PTC Starting Devices Type 103N

Release of new code numbers

Fig.1 PTC starting devices with front and side accessible screw connections

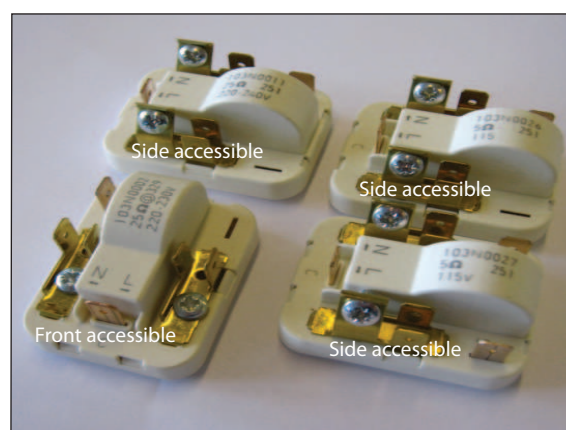
As pr. 1 November 2011 Secop launches two new PTC starting device code numbers with side accessible screw connections (Fig.1):

Code numbers 103N0011, 103N0026 and 103N0027 will replace PTC starting devices with front accessible screw connections 103N0002, 103N0003 and 103N0017, which can be purchased until our stock runs empty.

103N0002 will be replaced by 103N0011
103N0003 will be replaced by 103N0026
103N0017 will be replaced by 103N0027
(Fig.2)

Functionalities of the replacement code numbers are the same, only the screw accessibility is different.
